SERVICE LETTER No. L 138-Rev. 1

MODEL AFFECTED: Z 242 L aircraft, S/N: 0682

SUBJECT: Aircraft manufacturer instructions for detected cracks and defects and repair instructions.

ENCLOSURE No. 1 of Service Letter L138-Rev.1

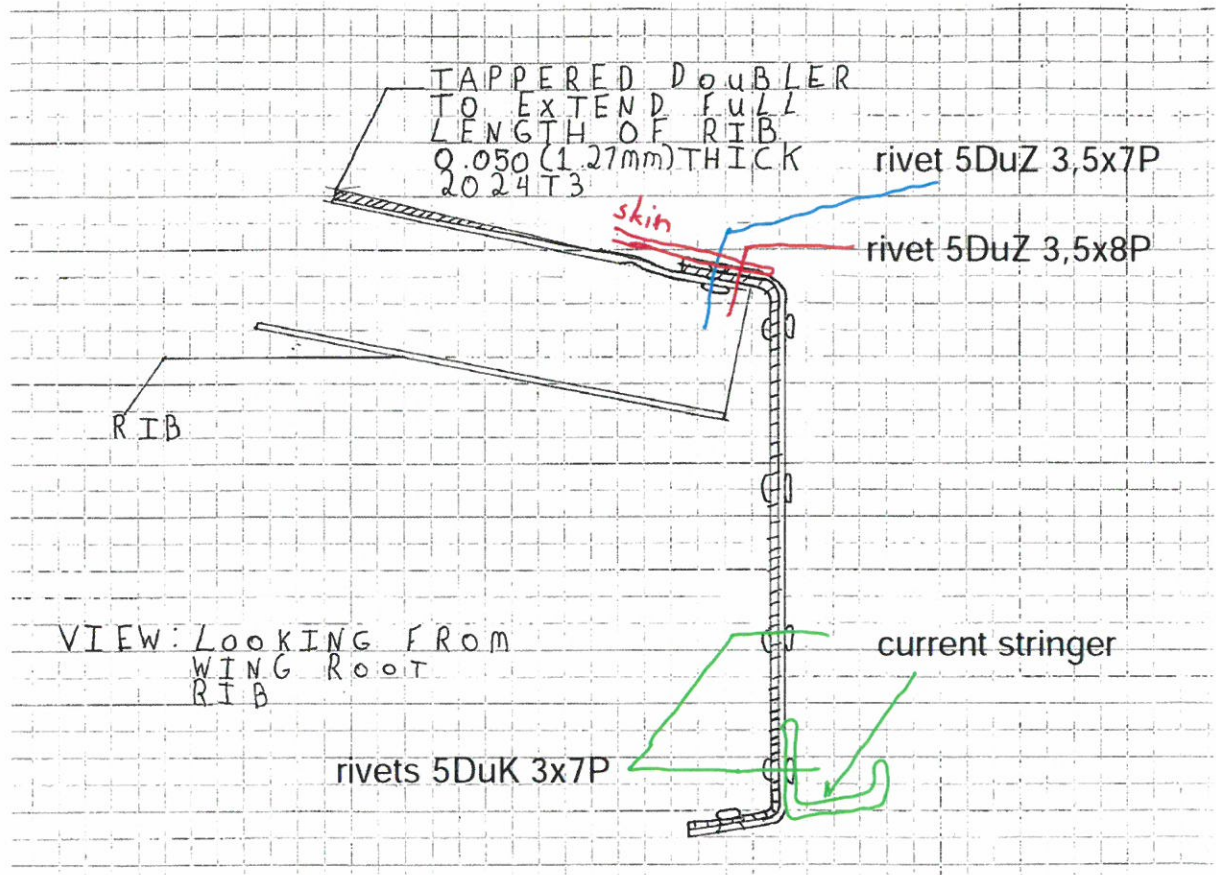
- Repair the aft spar cracks as described on pages 4-43 of the above-mentioned document. The cracked rib will be strengthened by the plate in accordance with the sketch provided by the operator's maintenance facility (see Enclosure No. 1)
- The rivets used for reassembly and plate reinforcement will be provided by ZLIN AIRCRAFT. The rivets must be positioned in accordance with the enclosed sketch (Enclosure No. 1) – see annotations made by ZA.
- All existing rivet holes must be re-drilled for new rivet size to assure their proper alignment.
- New holes for rivets (ČSN 02 2302.5, size 2,6) will be drilled in accordance with the sketch provided by the maintenance facility and annotated by the manufacturer.

NOTE: use the rivets provided by Zlin Aircraft
